# Access Compliance Report

## Public Rights-of-Way

Intersection ID: 23175	Main Street: ALEXANDER_HALL_DR	Cross Street: ALEXANDER_RD	Location: NW
ADA ID: 33BD2BDF160E	Ramp Type: PerpDiag	Initial Pass/Fail: Fail	Overall Compliance: No
		Severity Score: 25

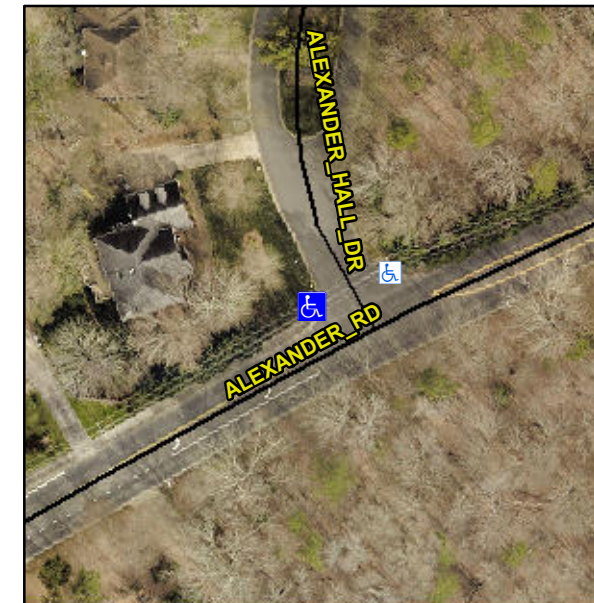
**Not Found, R304.2.2, R304.5.3**

Compliance	Description	Data	Compliance	Description	Data
N/A	Ramp Length (in)	59.0	No	Ramp Slope (%)	9.8
Yes	Ramp Width (in)	48.0	No	Ramp XSlope (%)	5.7
N/A	Flare Type LT	N/A	N/A	Flare Type RT	N/A
N/A	Flare Slope LT (%)	N/A	N/A	Flare Slope RT (%)	N/A
N/A	Flare Traversable LT?	N/A	N/A	Flare Traversable RT?	N/A
N/A	Landing Length (in)	N/A	N/A	DWS Provided?	N/A
N/A	Landing Width (in)	N/A	N/A	DWS Contrast?	N/A
N/A	Landing Slope (%)	N/A	N/A	DWS Length (in)	N/A
N/A	Landing X Slope (%)	N/A	N/A	DWS Full Width?	N/A
N/A	Landing Curb? (Y/N)	N/A	N/A	DWS Offset (in)	N/A
N/A	Shared Landing?	N/A			
N/A	Gutter Ponding?	N/A	N/A	Gutter Slope (%)	N/A
N/A	Gutter Lip Ht (in)	N/A	N/A	Gutter X Slope (%)	N/A
N/A	Painted X Walk1?	No	N/A	Painted X Walk2?	No
	X Walk 1 Direction	To NE		X Walk 2 Direction	To SE
N/A	X Walk 1 Width (in)	N/A	N/A	X Walk 2 Width (in)	N/A
	X Walk 1 Slope (%)	8.7		X Walk 2 Slope (%)	1.7
	X Walk 1 X Slope (%)	5.9		X Walk 2 X Slope (%)	1.9

**Remove & Replace Curb Ramp With Two New Directional Ramps or Equivalent.**
